Office Action Summary

10/750,175

DETAILED ACTION

FIG. 1 (PRIOR ART)

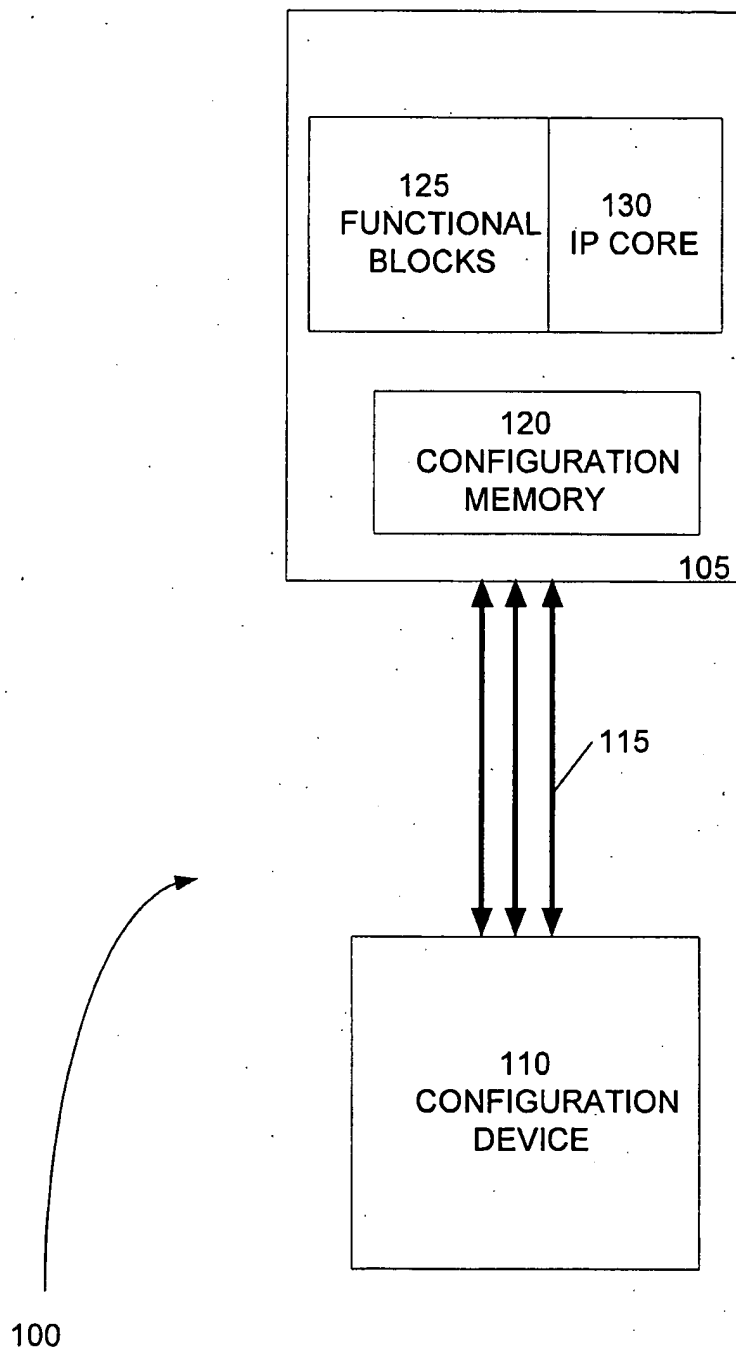
1. In view of the applicant's submission of new drawing FIG. 1, the examiner withdraws the objection to said drawing and approves the entry of FIG. 1.
2. In view of the applicant's amendments to claims 8 and 13, the examiner withdraws all objections to the said claims.
3. In view of the amendments to claims 8-10 and 11, the examiner withdraws the rejections of said claims under 35 USC 112 second paragraph.
4. In view of the amendment to claim 15, the examiner withdraws the rejection of said claim under 35 USC 101 as being non-statutory.
5. Applicant's arguments filed 3/19/2007 in respect to claims 1-20 have been fully considered but they are not persuasive. The applicant, in arguing the claims, has specifically cited the same limitation in each of the independent claims 1, 8 and 15, and
